# The Calcutta Gazette

WEDNESDAY, JULY 6, 1921.

### NOTICES TO MARINERS.

The following Notices are published for general information.

*Charts affected.*—No. 1026, The Solitary islands and adjacent coast.

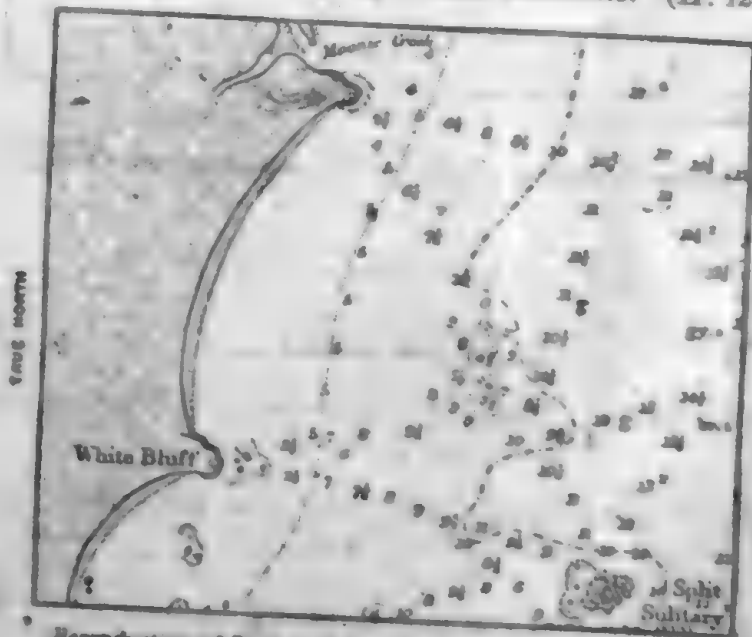
*Details.*—Amendments to the charts with regard to the reef north-westward of Split Solitary island, consequent upon a recent examination of the vicinity, are shown on the accompanying reproduction of a portion of chart No. 1026.

*Charts affected.*—No. 3401, Halsey harbour.

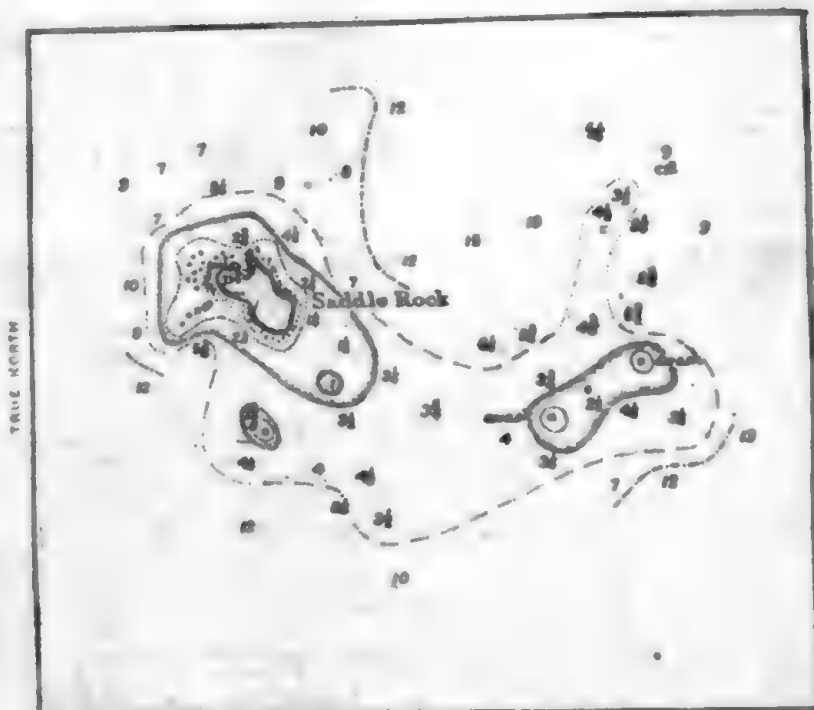
*Details.*—The accompanying reproduction of a portion of chart No. 3401 shows the necessary corrections to that chart with regard to the shoal eastward of Saddle rock.

Reproduction of Portion of Chart No. 2875

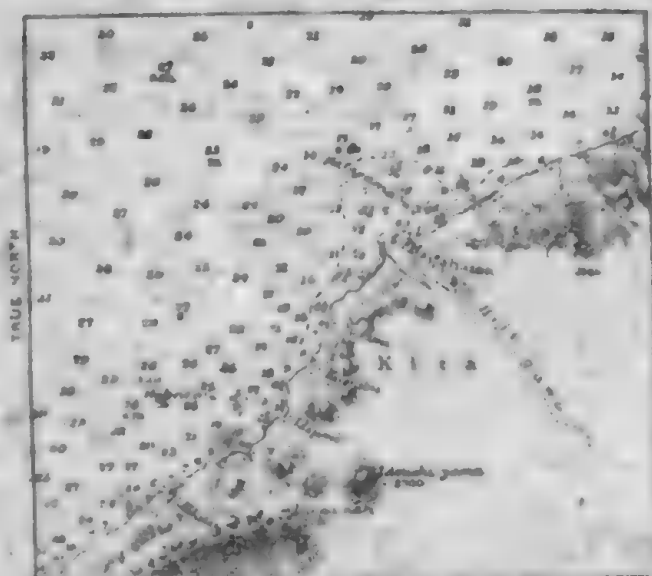
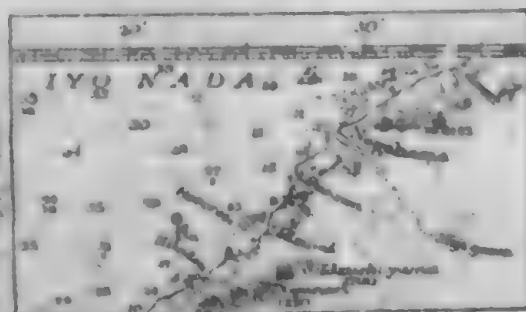
*Details.*—The accompanying reproduction of portions of charts Nos. 2875 and 1648 shows the necessary corrections to those charts with regard to depths, shoals and the coast line in the vicinity of Nagahama and approach.

*Charts affected.*—No. 3732, Penang harbour.

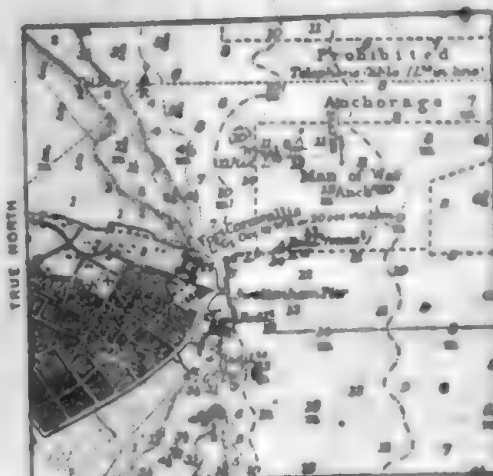
*Details.*—The accompanying reproduction of portions of charts Nos. 3732 and 1366 shows the necessary corrections to those charts with regard to Swettenham pier, the positions of the pier lights, and the alteration in position of the buoys in the vicinity of the pier.

Reproduction of Portion of Chart No. 2070

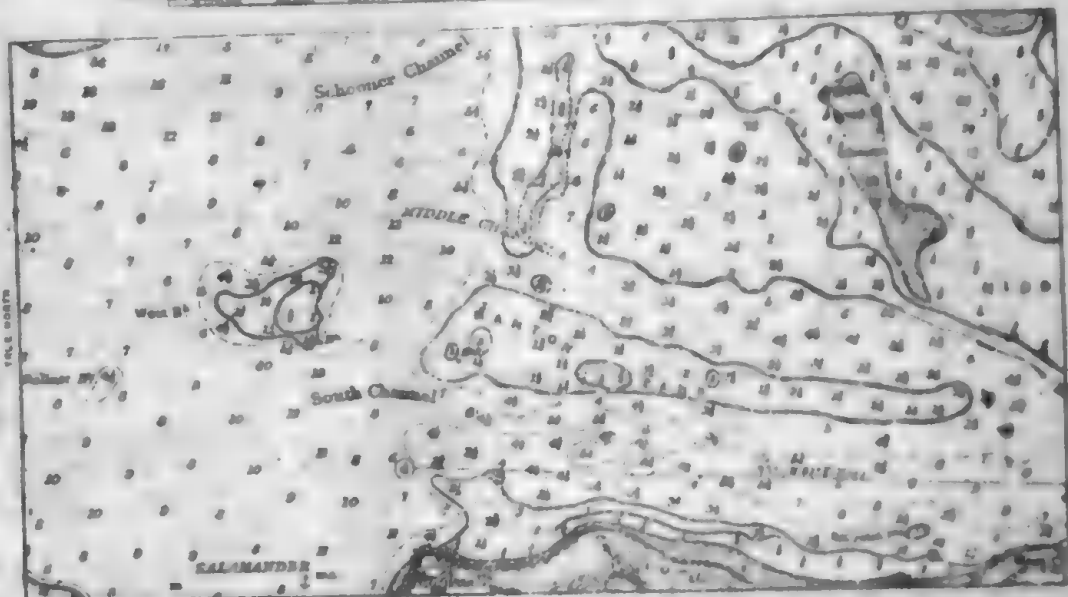
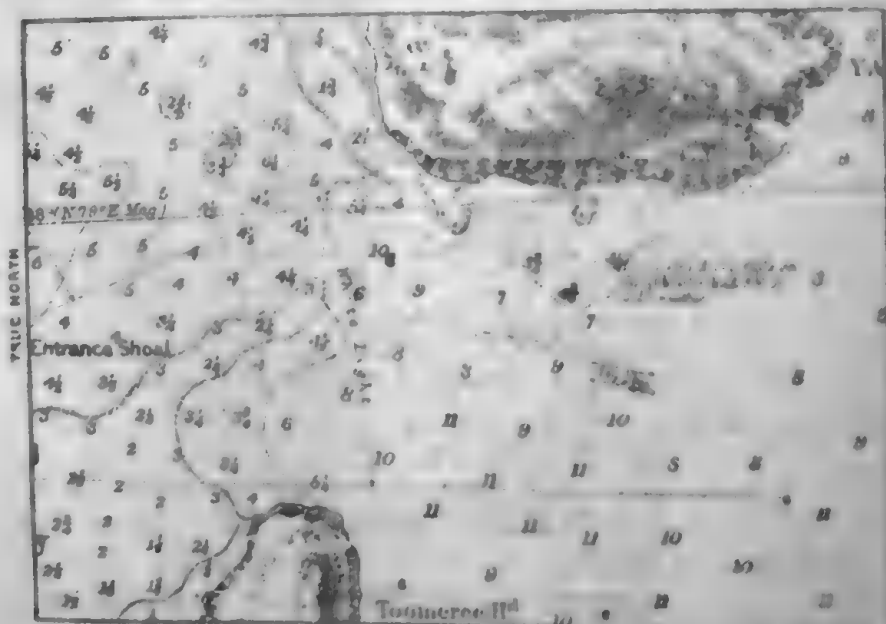
*Details.*—The accompanying reproductions of portions of charts Nos. 1070, 1021, 1024 and 3622 show the necessary corrections to those charts with regard to shoals, as revealed by a recent survey.

*Charts affected.*—No. 2747, Entrance to Port Phillip.

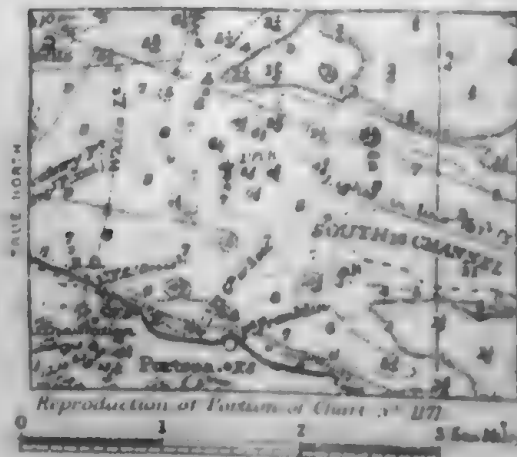
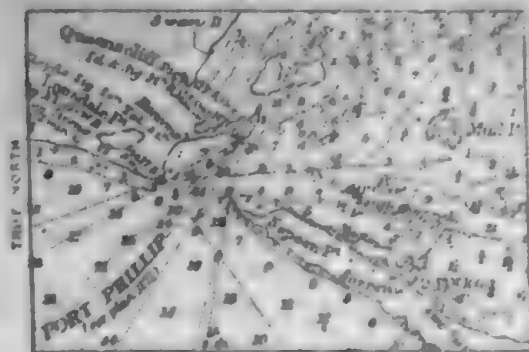
*Details.*—The accompanying reproductions of portions of charts Nos. 2747, 1171 and 1695b show the necessary correction to those charts with regard to alterations in depths in the South channel northward of Portsea.

From the reproductions it will also be seen that the positions of the light-buoy, Nos. 1, 2 and 3 buoys, and the buoy eastward of Portsea jetty have been slightly amended.

Reproduction of Portion of Chart N° 1293  
0 1 2 3 Sea Miles.

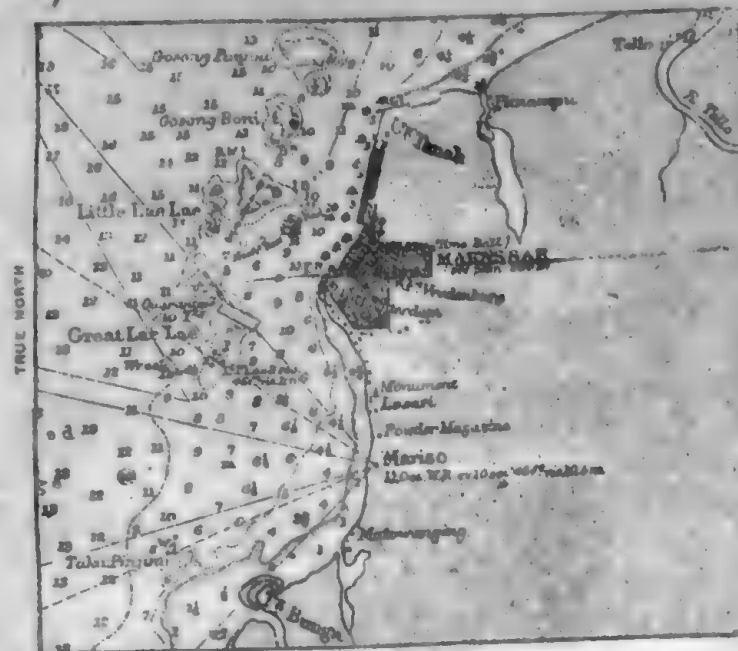
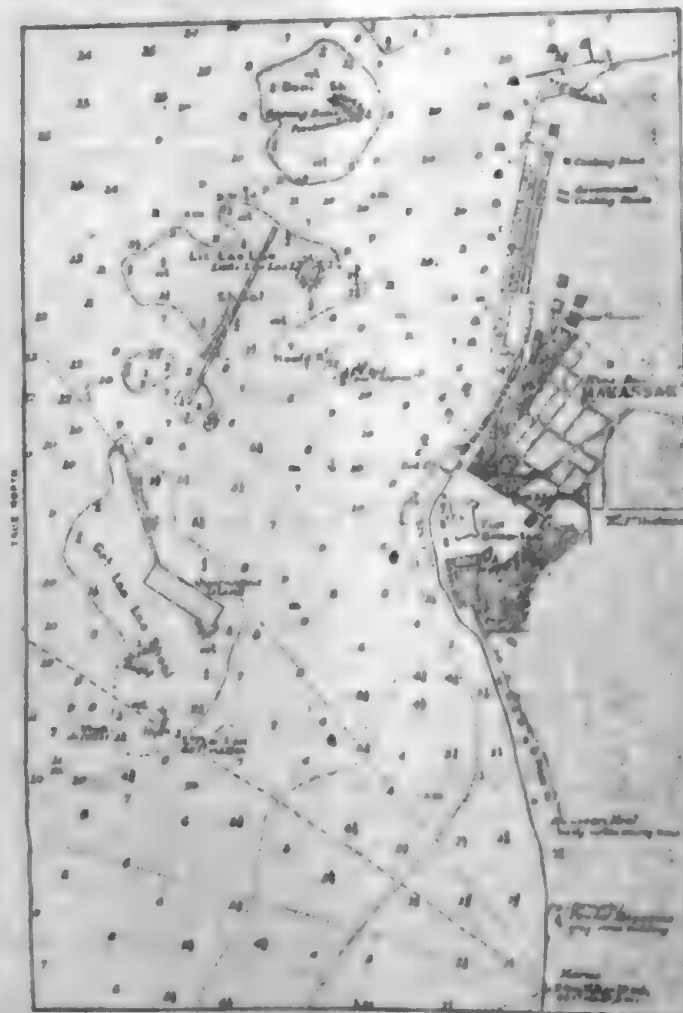
*Details.*—The accompanying reproductions of portions of charts Nos. 2662 and 1293 show the following:—

Reproduction of Portion of Chart N° 987

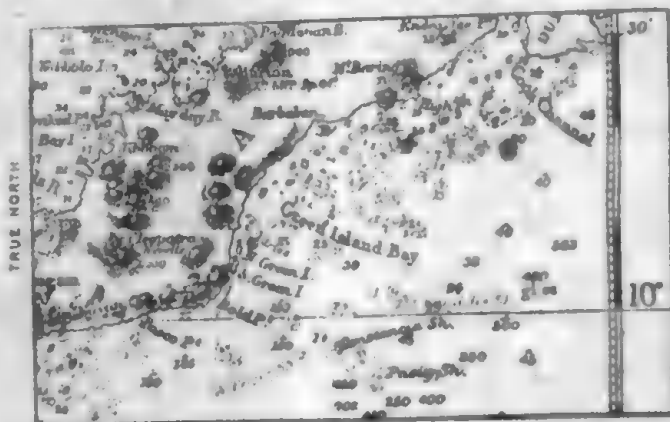
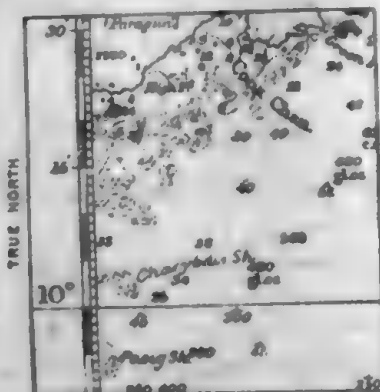
*Details.*—The accompanying reproductions of portions of charts Nos. 967, 2660, 943, 2578 and 1263 show the necessary corrections to those charts with regard to reefs and shoals between Deep bay and Dumaran island.

Reproduction of portion of plan on Chart No. 684

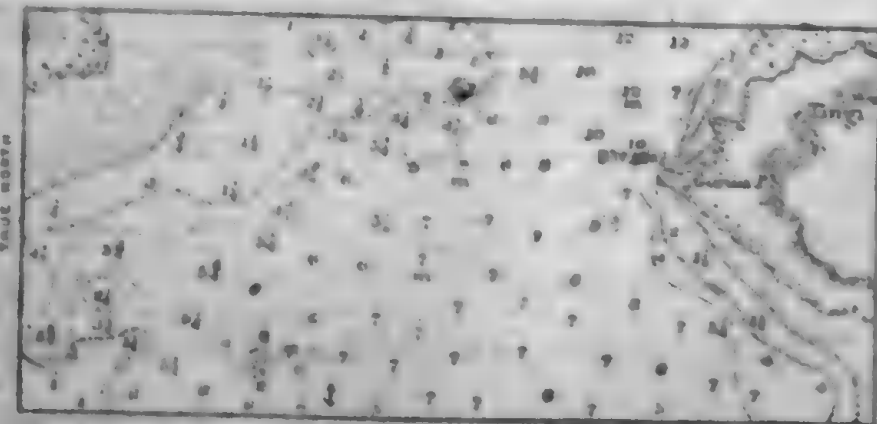
*Details.*—The accompanying reproduction of two portions of the plan of Mikindani harbour entrance on chart No. 684 shows the necessary corrections to that plan with regard to buoyage.

*Charts affected.*—No. 2265, Kobe and Hyogo bays.

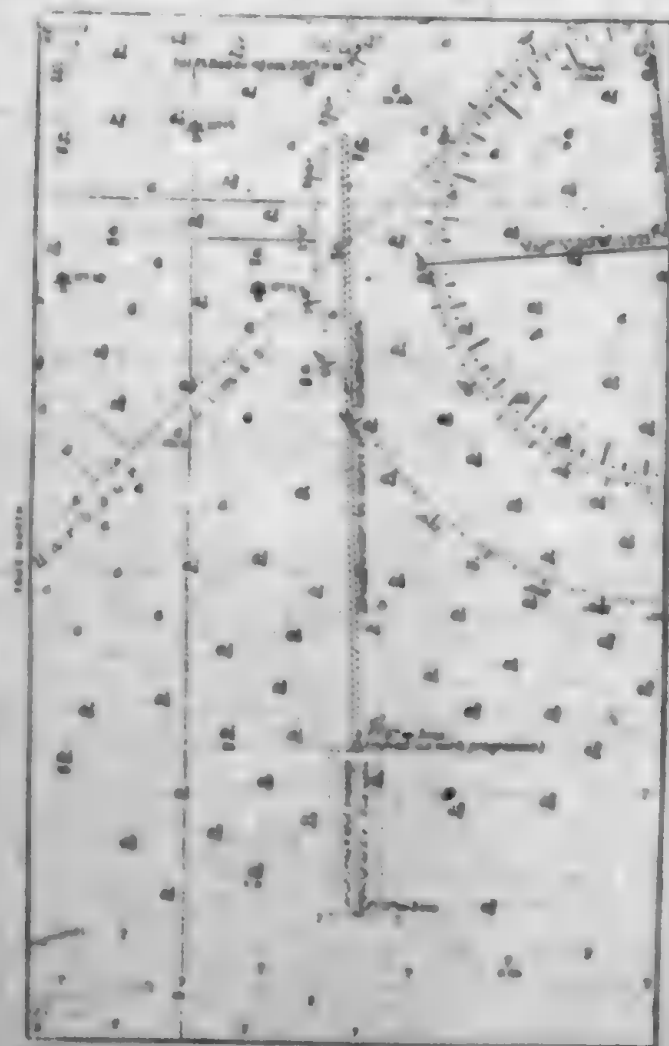
*Details.*—The accompanying reproduction of a portion of chart No. 2265 shows the projected limits of a detached breakwater in course of construction together with an area which is marked by light-buoys and within which anchorage and passage are prohibited; the prohibited area will be extended, and the northern light-buoy moved, as the work advances.

Reproduction of Portion of Chart N° 1884.

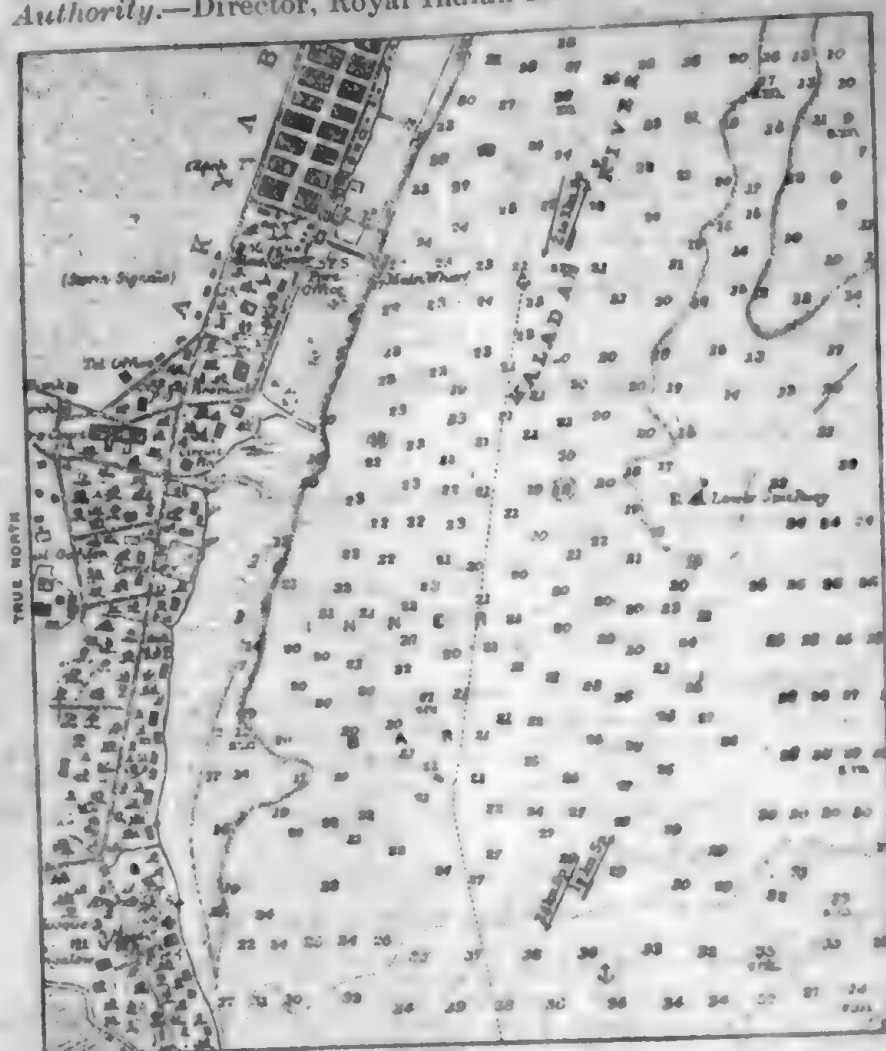
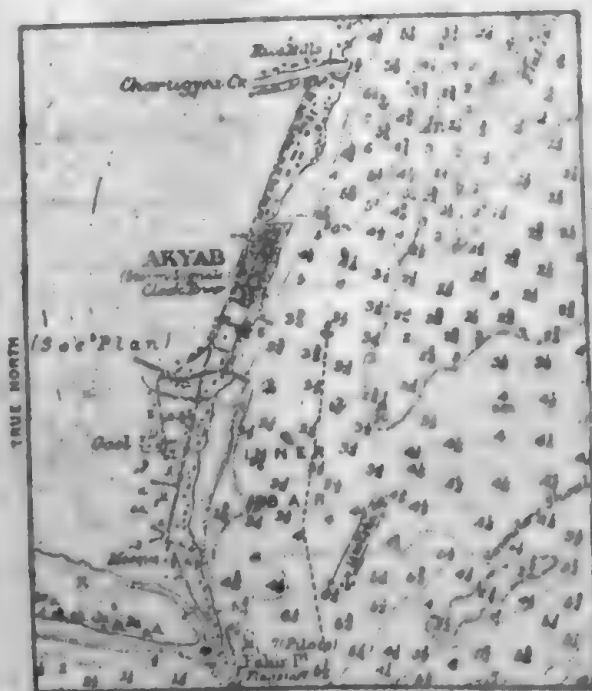
*Details.*—Amendments to the charts with regard to depths on the inner bar and vicinity, consequent upon a recent survey, are shown on the accompanying reproductions of portions of charts Nos. 1884 and 1369.

The new position of Lower Spit buoy and certain minor amendments to the chart in the vicinity of Akyab are also shown on the reproductions.

*Nagahama—Amendments to charts with regard to depths and shoals.*

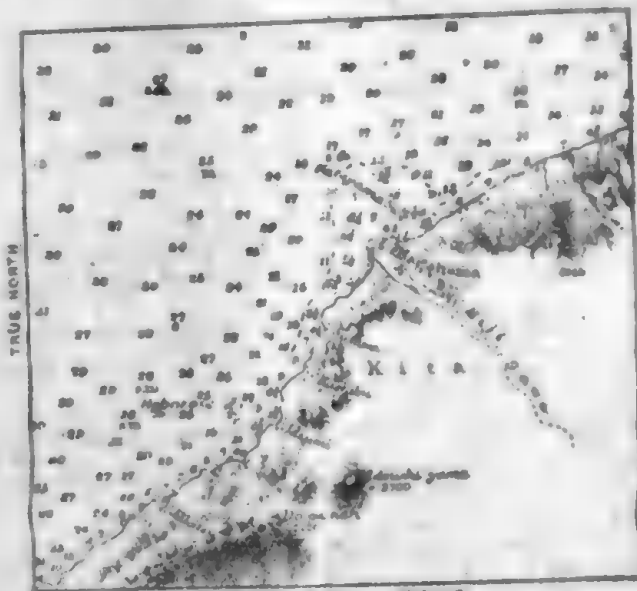
*Details.*—The accompanying reproduction of portions of charts Nos. 2875 and 1648 shows the necessary corrections to those charts with regard to depths, shoals and the coast line in the vicinity of Nagahama and approach.

Reproduction of Portion of Chart N° 1070

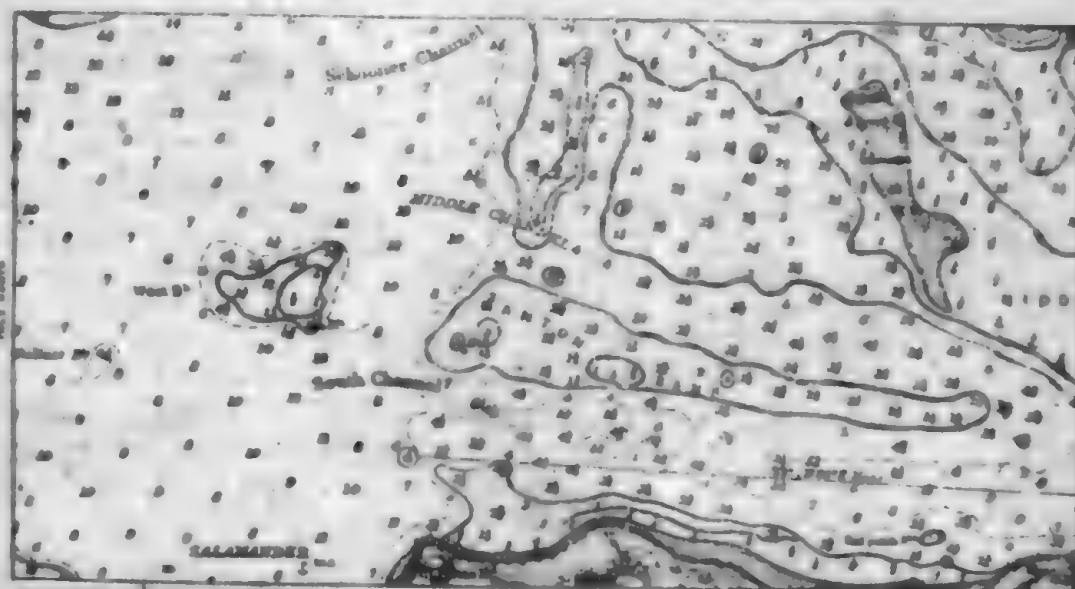
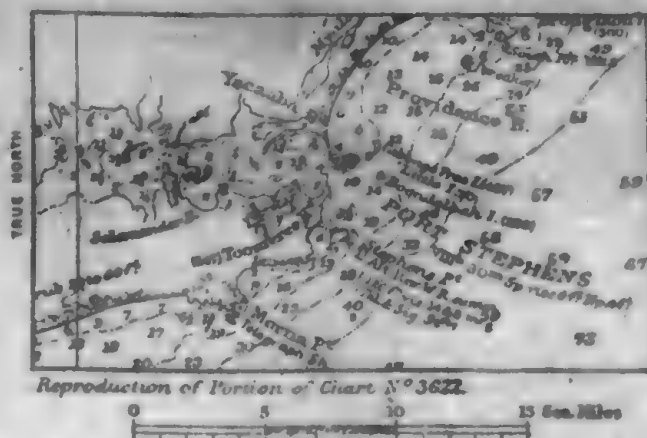
*Details.*—The accompanying reproductions of portions of charts Nos. 1070, 1021, 1024 and 3622 show the necessary corrections to those charts with regard to shoals, as revealed by a recent survey.

Reproduction of Plan of Chart No. 2200

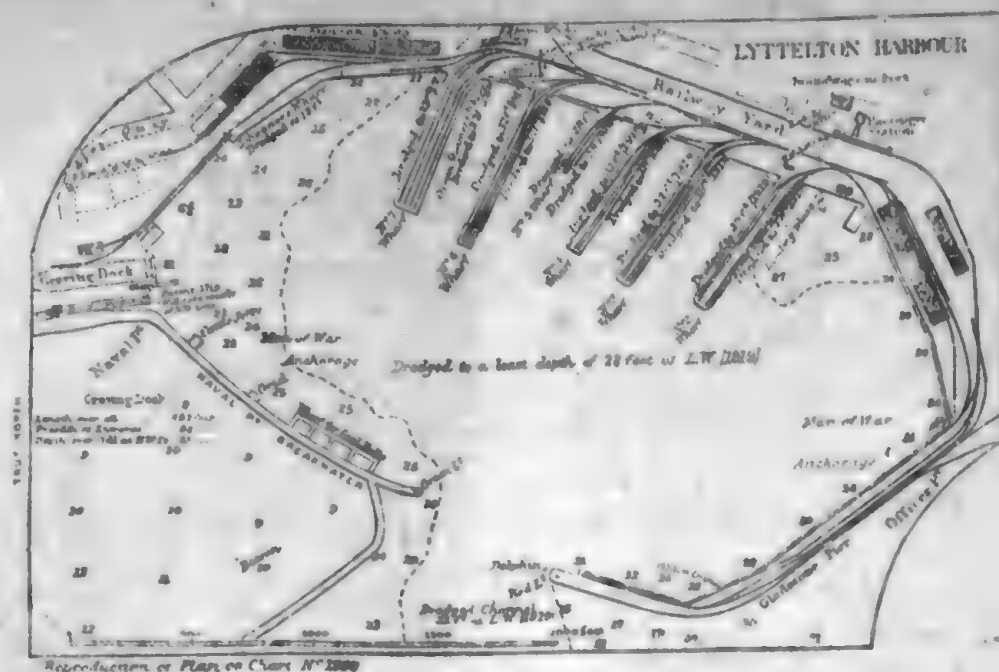
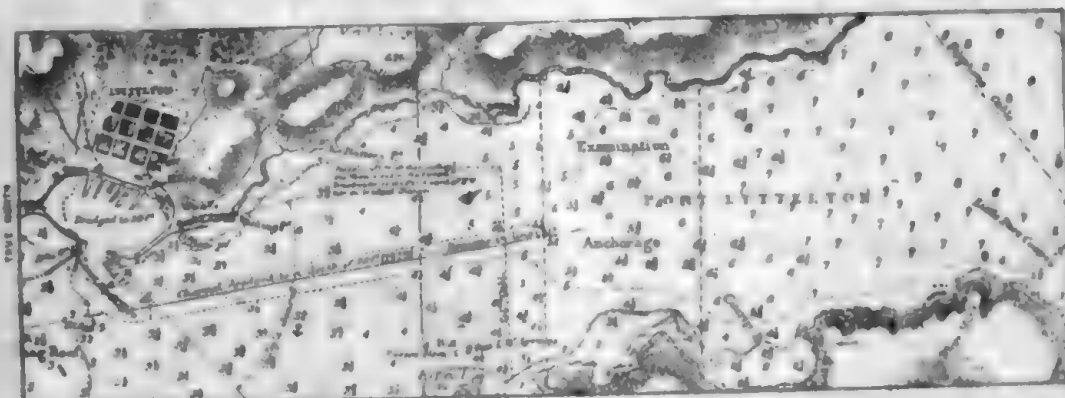
*Details.*—The accompanying reproductions of portions of chart No. 1999, show the necessary corrections to that chart with regard to the depths in Lyttelton harbour and the entrance channel.

Reproduction of Portion of Chart N° 967

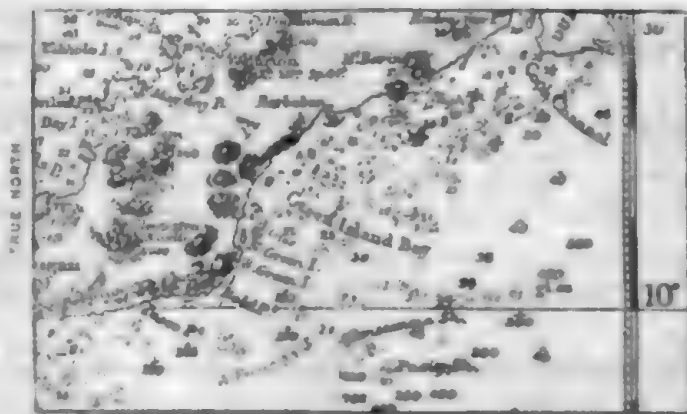
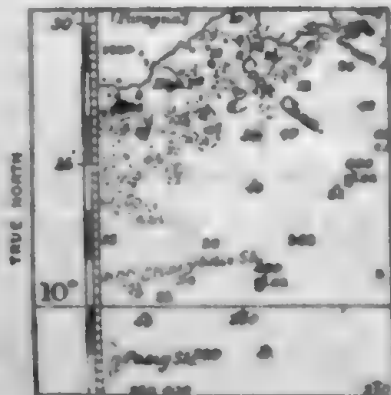
*Details.*—The accompanying reproductions of portions of charts Nos. 967, 2660b, 943, 2578 and 1263 show the necessary corrections to those charts with regard to reefs and shoals between Deep bay and Dumaran island.
